City of Santa Fe, New Mexico

memo

2026-012491-HDRB. 511 Paseo de Peralta. Downtown & Eastside Historic District. Marisol Ortiz, agent for Peralta's Walk LLC, owner, proposes to construct a 6,212 sq. ft. multi-family residence to a height of 27'-6", where the maximum allowable height is 23'-0" on a sloping vacant lot.

Figure 3: Proposed Site Plan

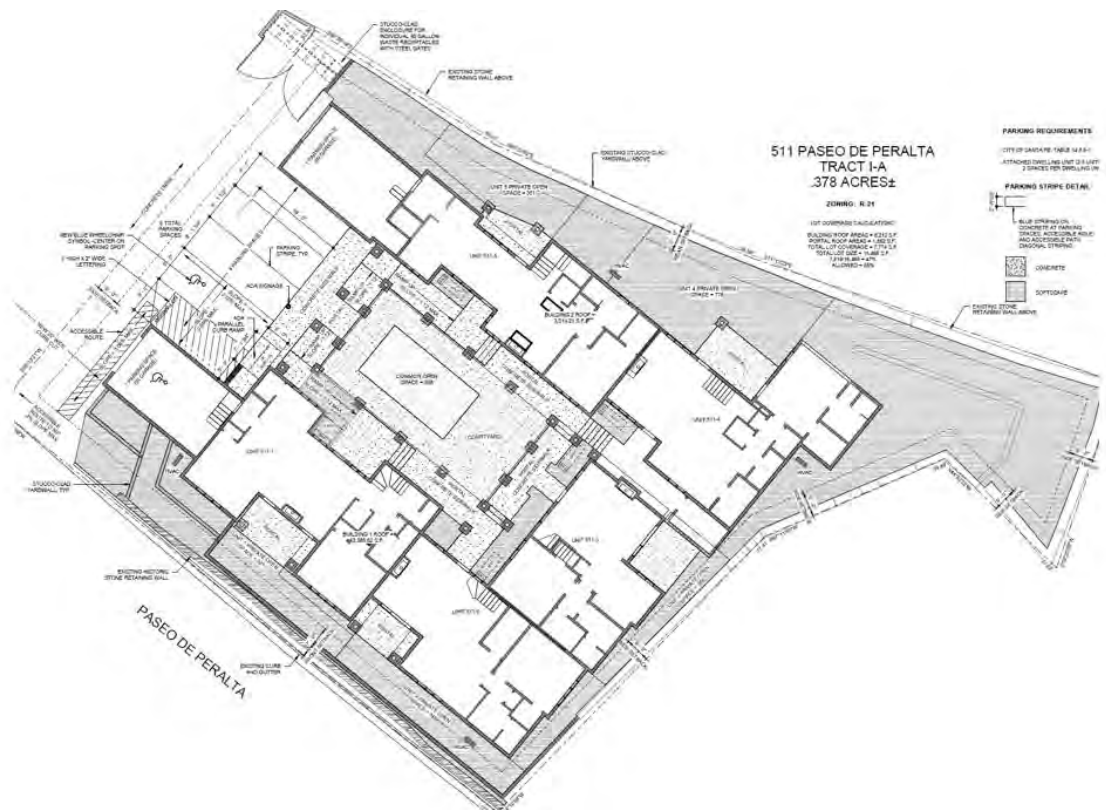
- 1) Construct a 6,212 sq. ft. multi-family residence to a height of 27’-6” where the maximum allowable height is 23’-0” on a sloping vacant lot. All buildings are of Pueblo Revival design with earth-toned stucco finishes designed with flat roofs and parapets. Each building uses a variety of setbacks and offsets to break up the massing. The proposed project includes 5 condominiums in a two-story building. The tract is zoned R-21, which allows for multiple units on the lot. The tract has an approved 2023 Development Plan with the city, which matches this request. Detail finishes include stone caps on chimneys and metal fascia, columns, roofing, and railing. Windows are wood-clad. Yard walls, to a height of 6’-0”, will define the private open spaces behind the existing historic stone wall. The existing historic stone wall will remain with no modifications.

Figure 4: Proposed North Elevation

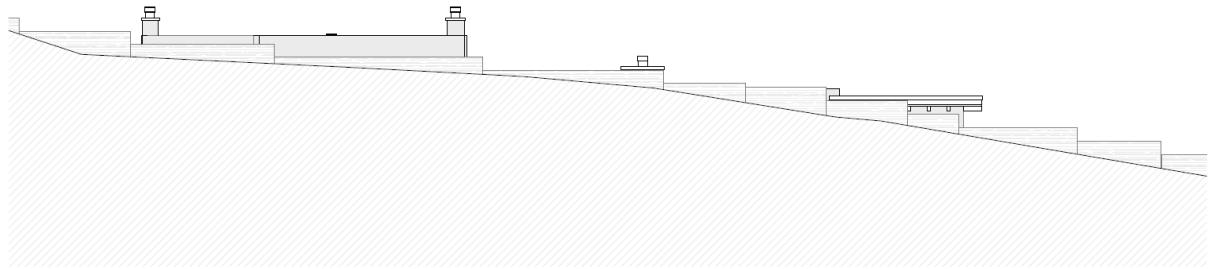
1. Unit 1, remove the window in the Office looking directly to the portal.
2. Unit 2, remove the door under the portal that directly accesses the Kitchen.
3. Unit 3, under the portal, change the single door and double window to a double door and a single window.
4. Unit 4, under the portal, change the single door and single window to a single door.
5. Unit 5, in the Dining room, decrease the window from size from three windows to a double window.

1. Unit 1, at Bed 1, change the single door and double windows to double doors on the north and south elevations accessing the decks.
2. Unit 2, in Bed, change from triple windows to double doors accessing the deck.
3. Unit 4, Bed 2, remove the door on the north elevation to the non-existent overhang.
